**Barry Ash Pond Review  
Barry Power Generating Facility  
Mobile, Alabama**

**Mobile Baykeeper**

March 23, 2018

**Figure 4-1**  
**Engineering Section Through Northeast Dike**

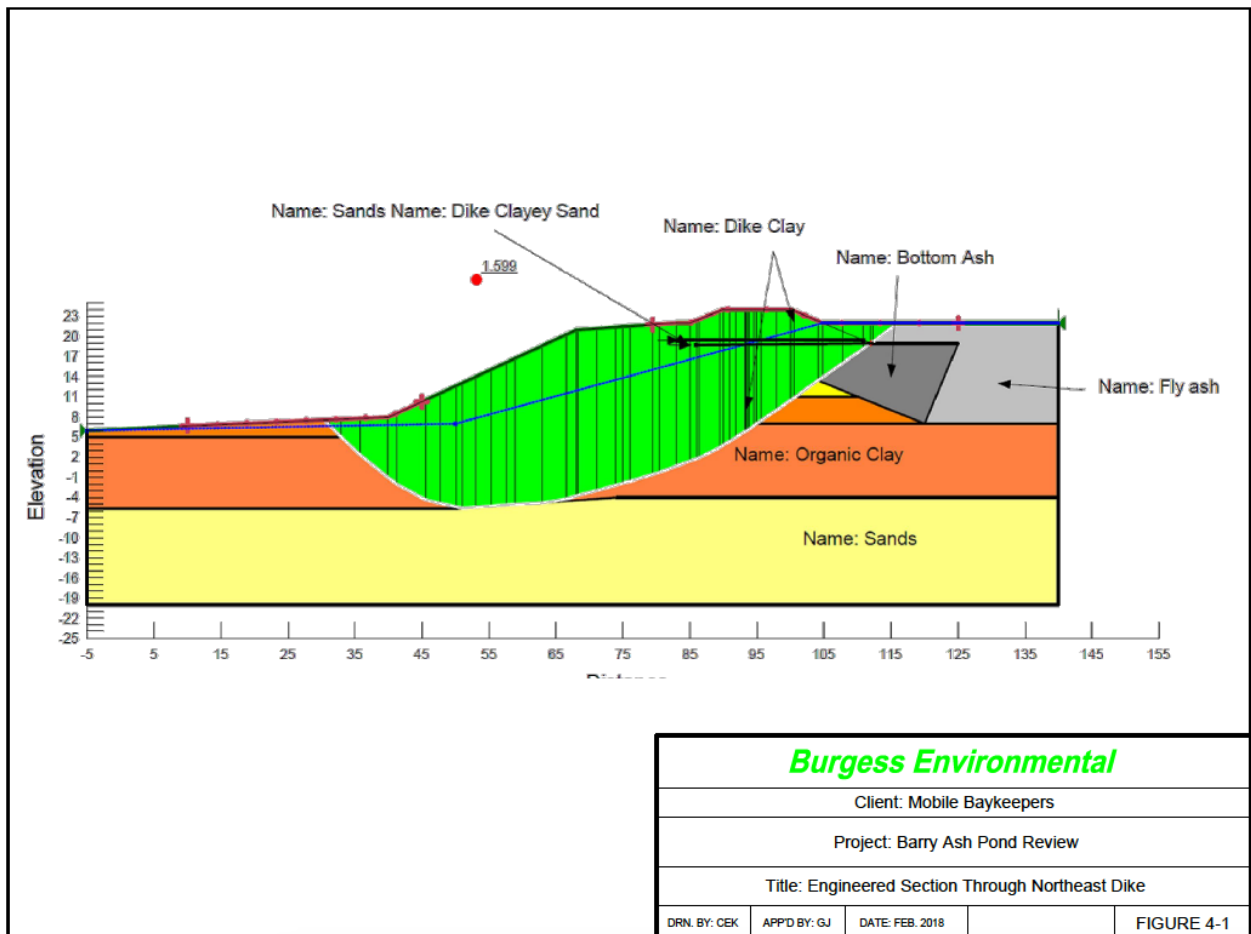
that were obtained from previous reports. The stability analyses were completed for the 'critical section' along the northeast main dike, although the criteria used to establish the critical section was not explained. Liquefaction analysis was not completed because the dikes were determined by Pegues as not susceptible to liquefaction. It is standard practice to consider this potential mode and liquefaction analysis should have been completed for the Barry Pond. In particular, liquefaction analysis should have been completed for the dikes that are founded on ash and sand that could be susceptible liquefaction.

The dikes were constructed primarily on organic clay, which is in turn underlain by alluvial sands. The dikes are reported to be constructed using clay and clay sand, with some bottom and fly ash used in portions of the dike construction. Soil properties used in the analyses are summarized in Table 4.1. The Pond was assumed to be full of bottom and fly ash, and the water level was assumed to coincide with the elevation of the top of the dike. A schematic view of the dike cross-section used in the stability analysis is presented in Figure 4-1.

The calculated factors of safety varied between 1.6 and 1.5 for the normal, maximum pool and seismic cases, which complies with the requirements of the Standards (1.5 to 1.0). The factor of safety calculation represents the ratio of stabilizing to destabilizing forces. The assessment did not include an analysis of settlement and differential settlement, which would appear to be warranted based on the presence of relatively thick organic clay underlying the northeast dike.

**Photo 3: Evidence of River Bank Erosion (Feb. 9, 2017)**

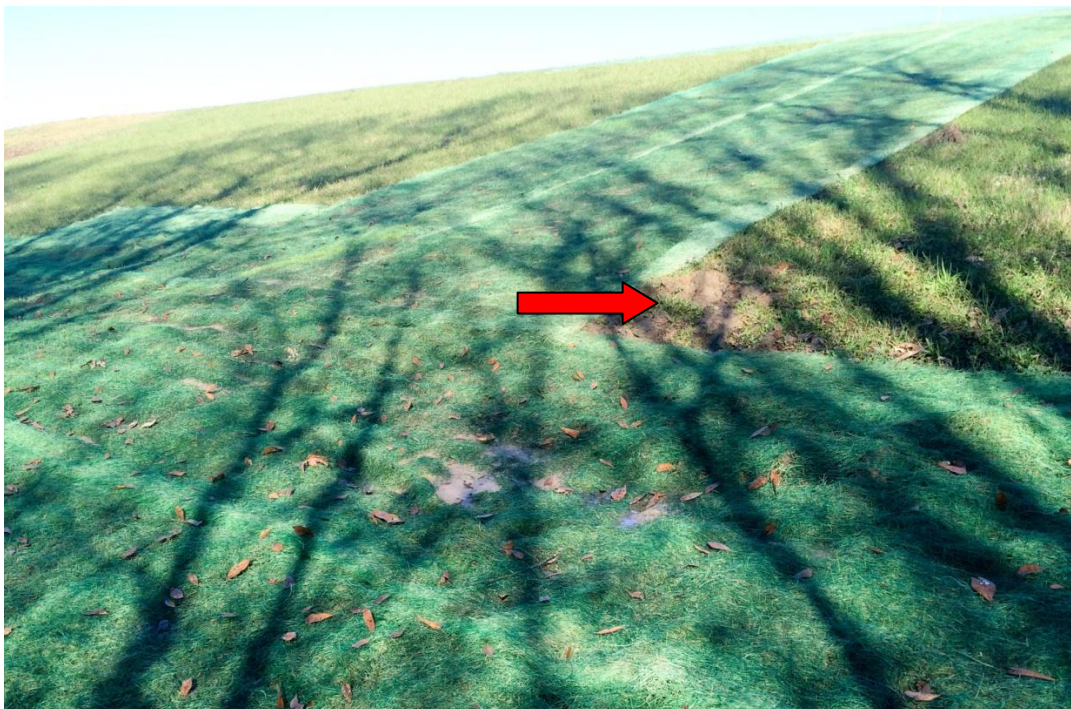
Erosion can occur two ways, as erosion of the river embankment and dike foundation soils, and as wave erosion during periods of flooding. Both can result in failure of the dikes. River erosion, as shown in Figure 3, is an ongoing process that results in meandering of a river through its floodplain. Bank erosion is clearly evident along the west bank of Mobile River. Over time, this
